## ADDENDUM #4

RE: Solicitation Addendum #4 to RFP #25-01/KVMH Emergency Department Renovation, Phase 3

**EMERGENCY DEPARTMENT RENOVATION**  
Kauai Veterans Memorial Hospital  
4643 Waimea Canyon Drive  
Waimea, Kauai HI 96796

SHEET TITLE  
CIVIL SITE AND GRADING PLAN

**A** CIVIL SITE AND GRADING PLAN  
C1.0 SCALE: 3/32" = 1'-0"

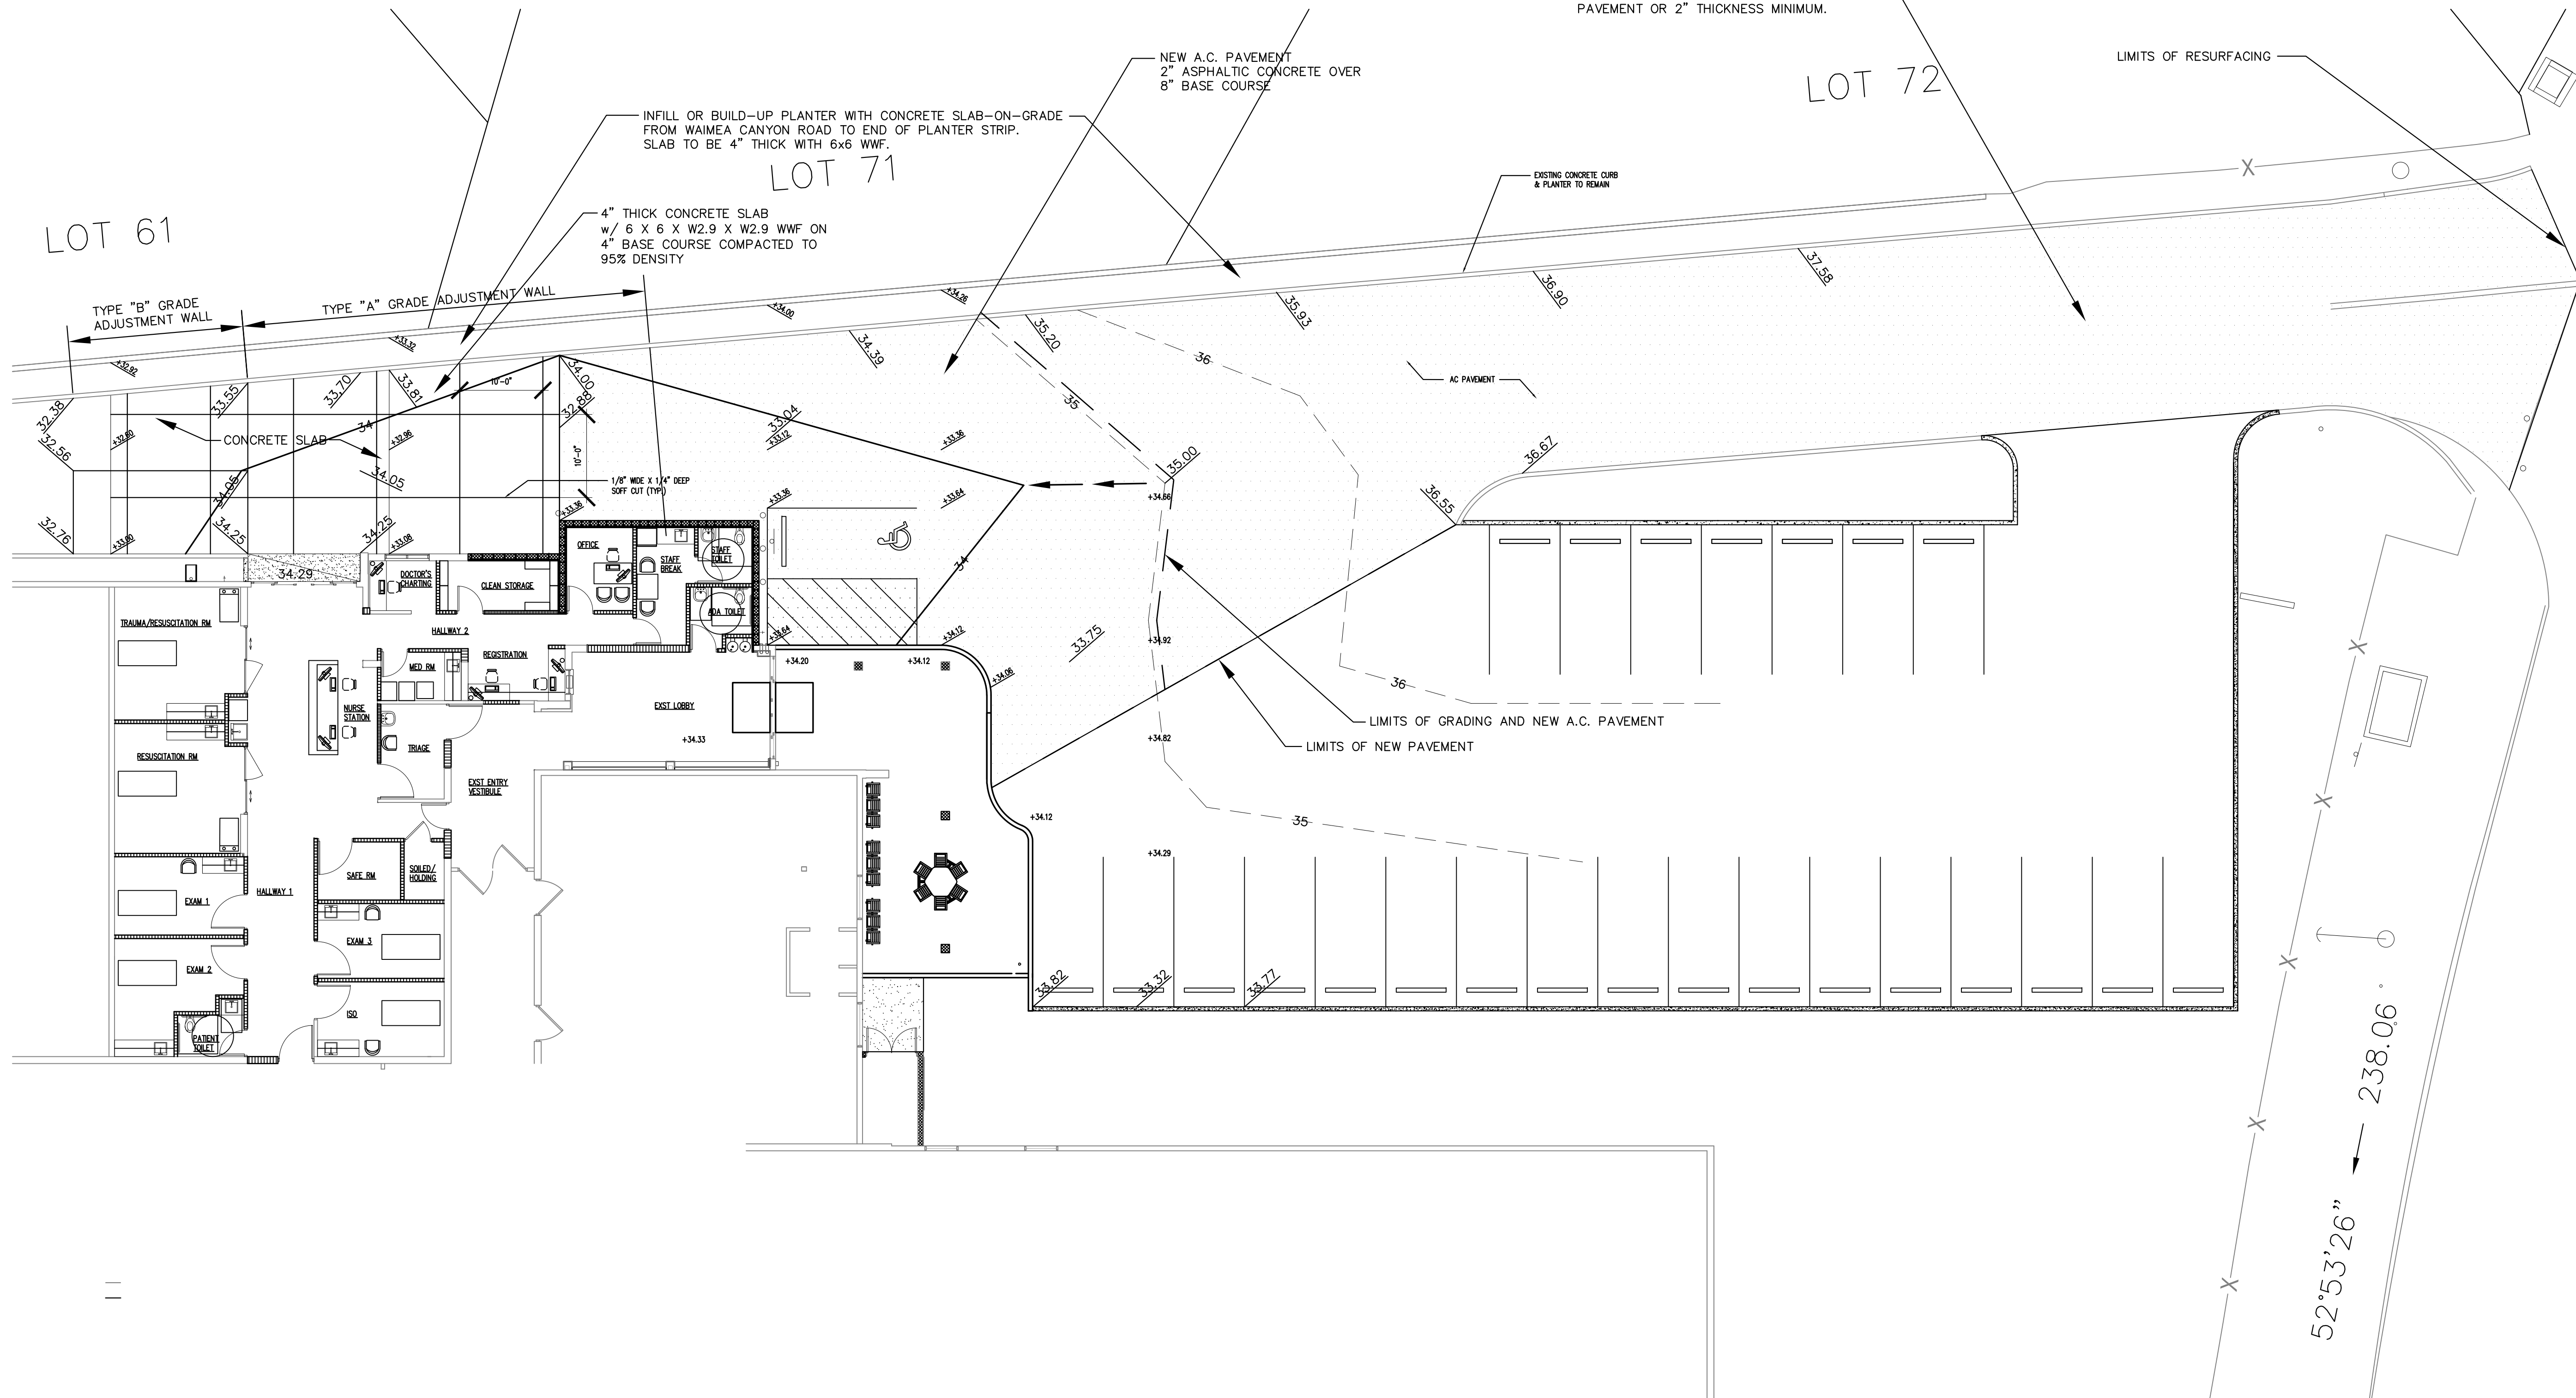
1. The attached drawing was provided. Transition to entry was revised due to 12" elevation difference.
2. Due to the recent change, we have opened up a second RFI period. Closing date for receipt of questions is October 11, 2024.
3. New closing date for receipt of proposal is 2:00 p.m. on October 25, 2024.

COLD PLANE AND REMOVE EXISTING  
A.C. PAVEMENT. RE-COMPACT BASE  
COURSE AND PAVE WITH NEW A.C.  
PAVEMENT. THICKNESS TO MATCH EXISTING  
PAVEMENT OR 2" THICKNESS MINIMUM.
